# Evolution of UNECE R29

## OICA proposal

GRSP Informal Group on Cab Strength - 12 December 2006

## Frontal impact of UNECE R29:

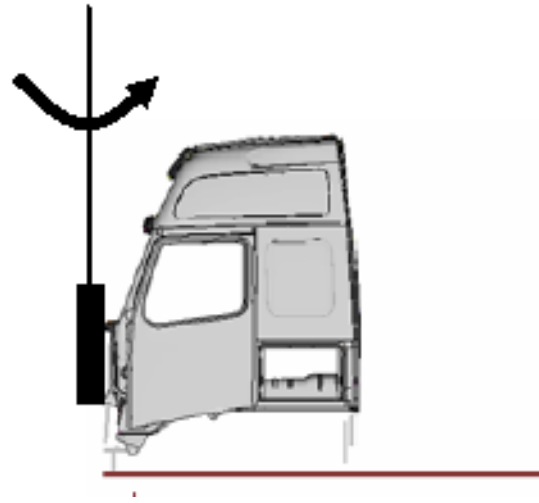
- Based on truck impacting rear of preceding truck
- Accident statistics confirm current impact configuration:
  - Impactor size 2500 x 800 mm
  - Centre of Gravity (CG): 50 mm below R-point
  - Large majority of overlap 75 – 100 %
- Energy for trucks > 7.5 t GVM could be increased to **50** kJ (+14%) to increase severity and occupant protection
- Any reduction of impactor size would require maintaining current energy level of 44.1 kJ and redefinition of location of impactor (**150** mm below R-point) to avoid interaction with lower windscreens

# 180° rollover – OICA proposal

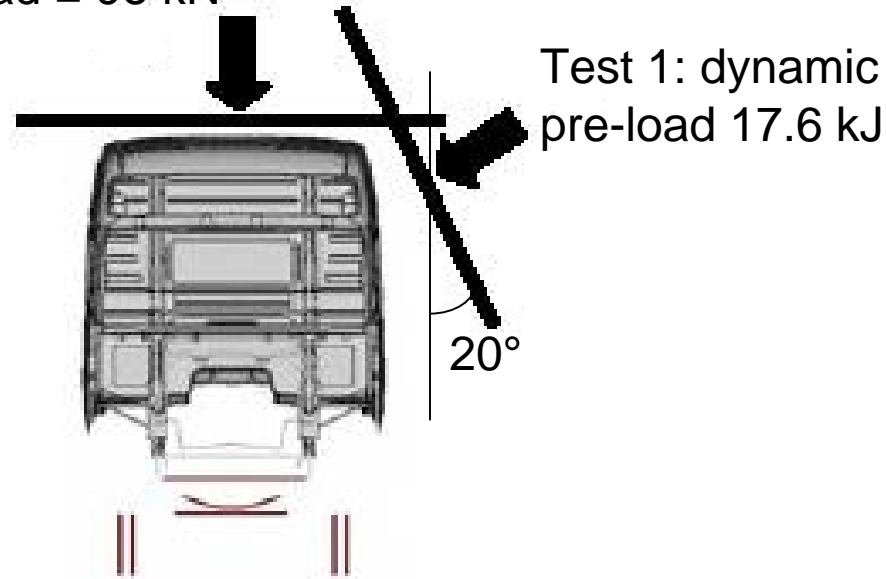
- Rigid platen
- Inclined 20° to the vertical
- Energy level: 17.6 kJ
- Direction of the impact: perpendicular to the longitudinal axis of the cab

## Test 2 – quasi-static load:

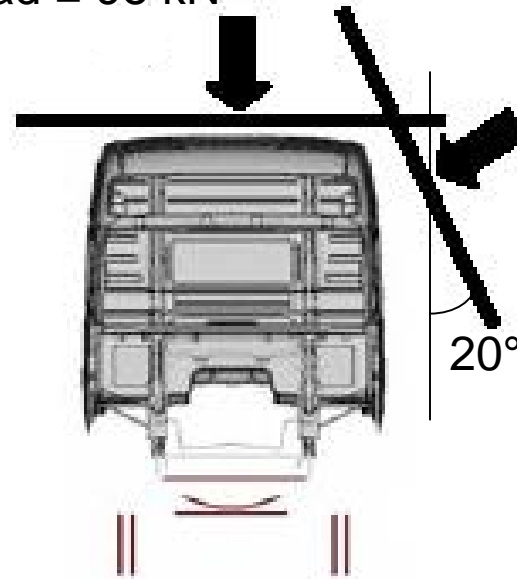
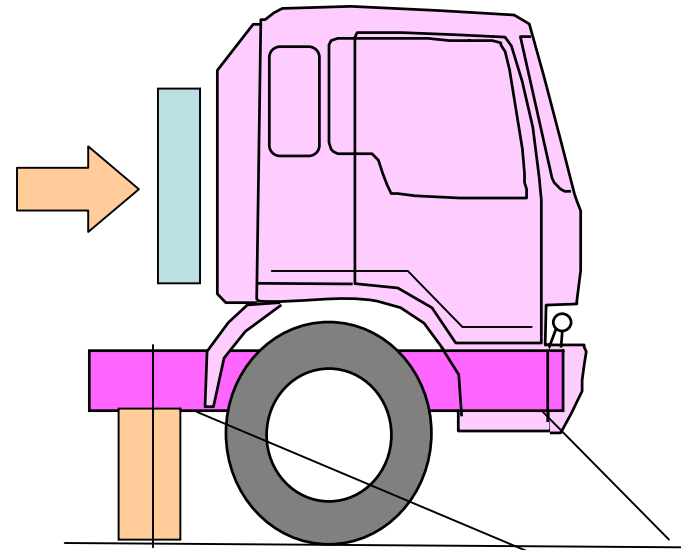
- On same cab as test 1
- Rigid platen
- Force = maximum authorised load front axle(s),  $\leq 98$  kN
- Direction of the load: vertical

## Rear wall test:

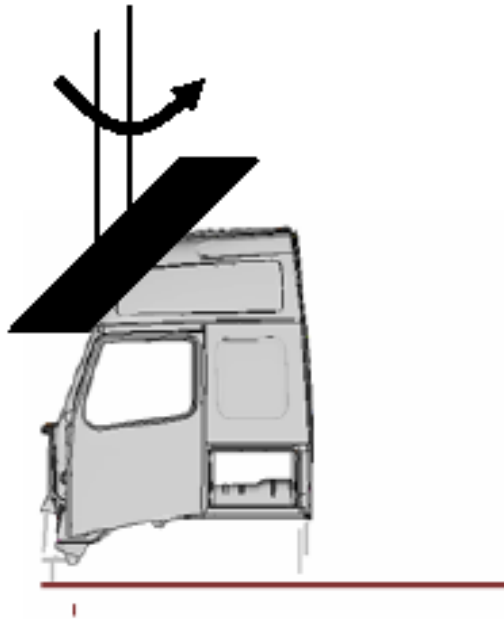
- Supposed to represent impact by load shifting forward
- Accident statistics show very few injuries (< 2%)
- Test is irrelevant for most heavy truck configurations (load separated from cab)
- Test is irrelevant for lighter trucks (1-box)
- Test should be **deleted** altogether and **replaced** by far more important accident configuration (see below)

## A-pillar test:

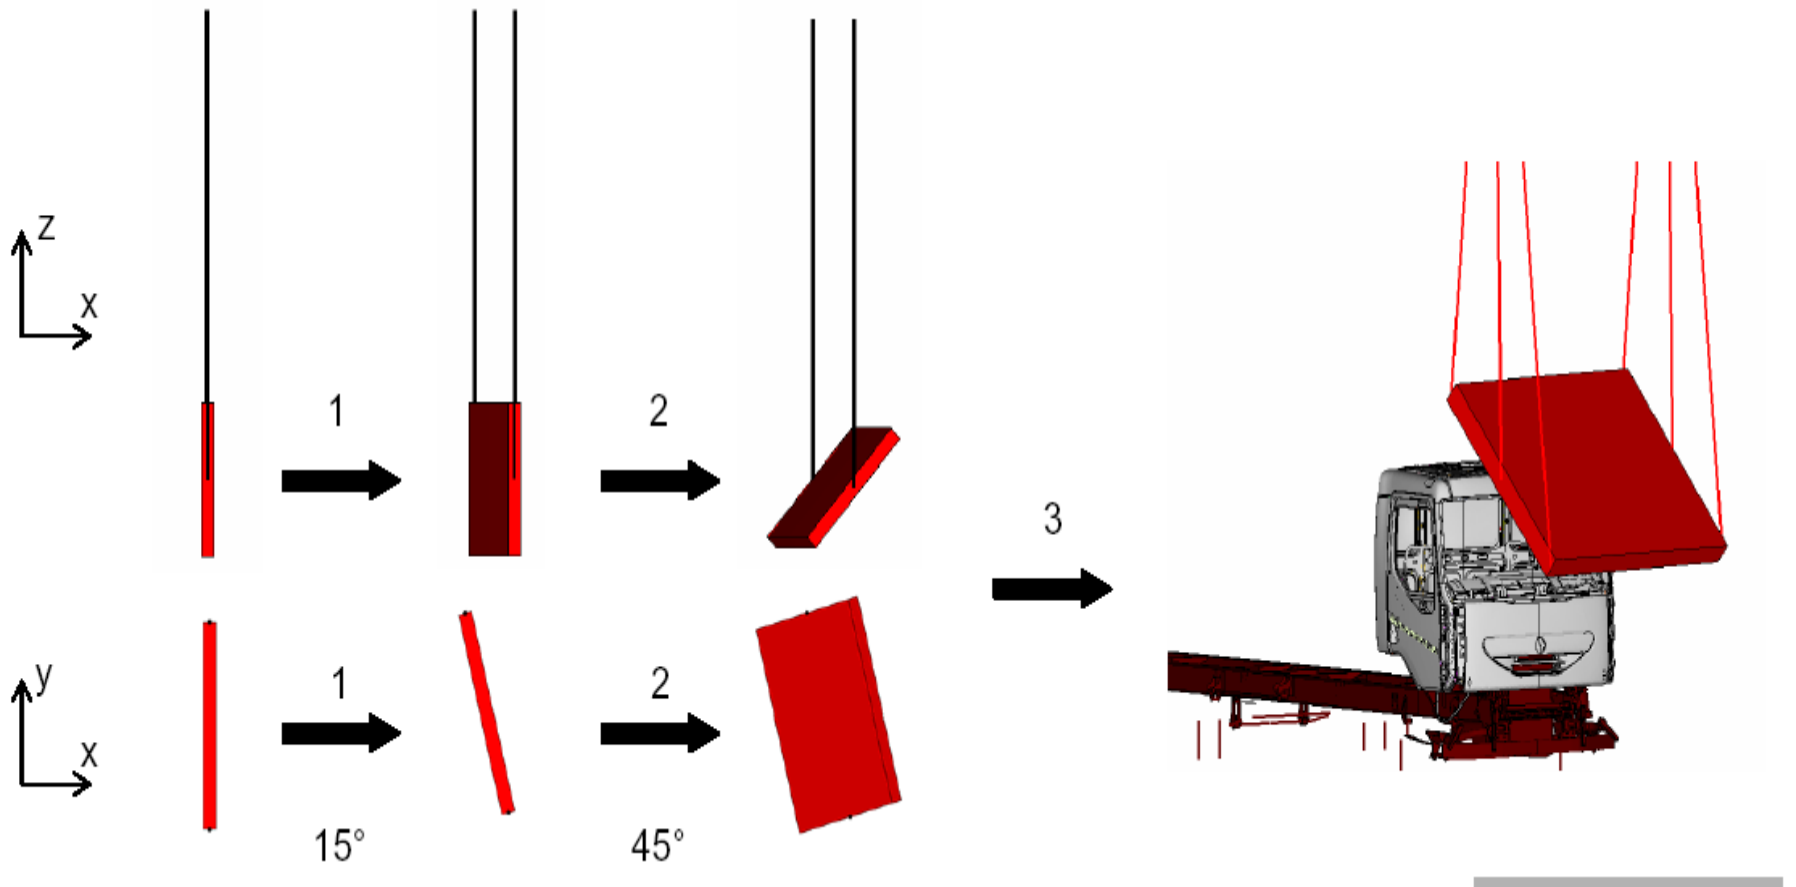
- Steel pendulum  $\geq 1,000$  kg
- Inclined  $45^\circ$  to vertical,  $15^\circ$  in horizontal XZ plane
- Impact direction:  $15^\circ$  to vehicle longitudinal axis
- Impact energy 30 kJ
